MIL-L-63460D
AMENDMENT 5
5 DECEMBER 1993
SUPERSEDING
INTERIM AMENDMENT 4(AR)
27 MAY 1993
AMENDMENT 3
1 JULY 1987

MILITARY SPECIFICATION
LUBRICANT, CLEANER AND PRESERVATIVE FOR WEAPONS AND WEAPONS SYSTEMS

This amendment forms a part of MIL-L-63460D, dated 5 August 1985, and is approved for use by all Departments and agencies of the Department of Defense.

FIGURE 2. Bottle, 0.5 Oz Cylindrical.

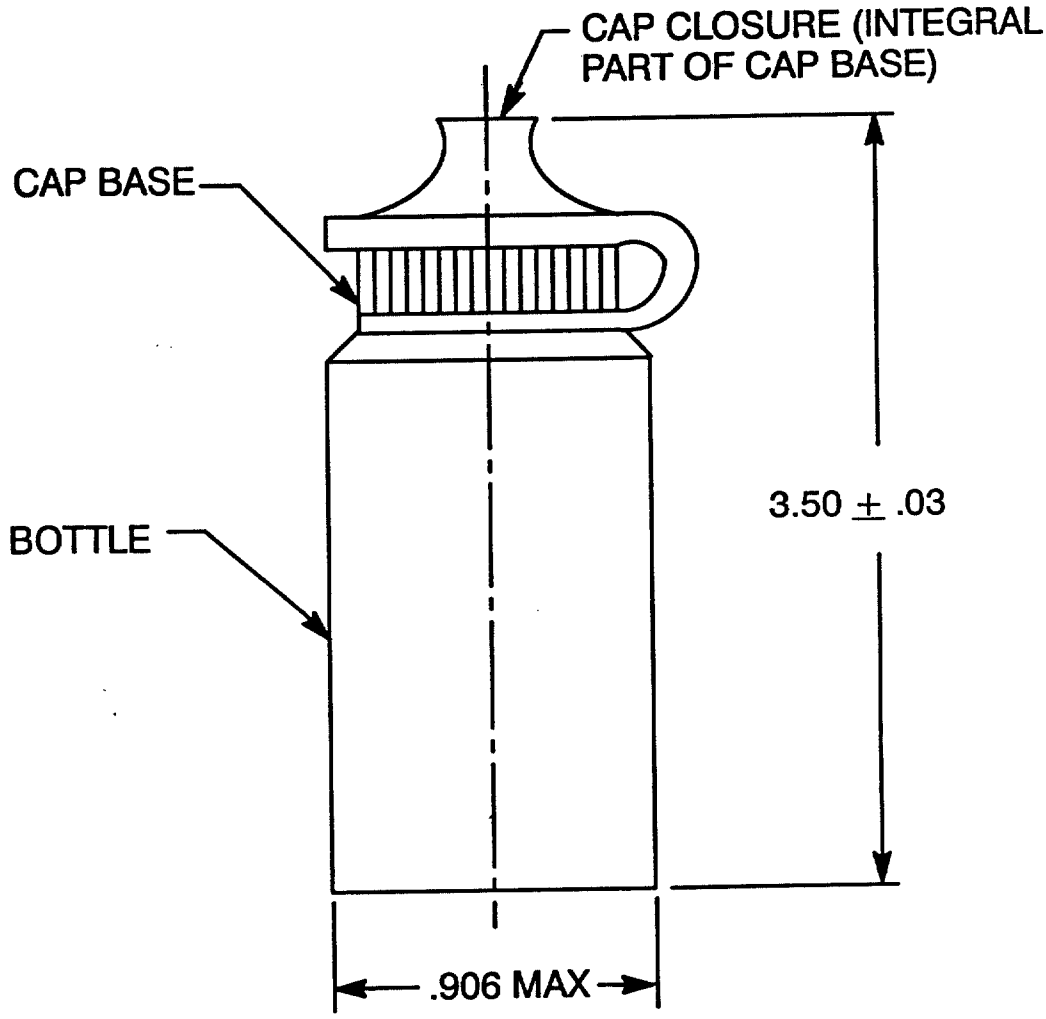
5.1.2 Bottle, 0.5 oz. When the unit container specified is of the 0.5 oz size, the bottle material and dimensions shall conform to Figure 2.

6.6: DELETE reference to "9150-01-079-6123" and "1.1 fl oz plastic bottle IAW drawing", and INSERT in place "9150-01-102-1473" and "0.5 oz plastic bottle (See Figure 2)".
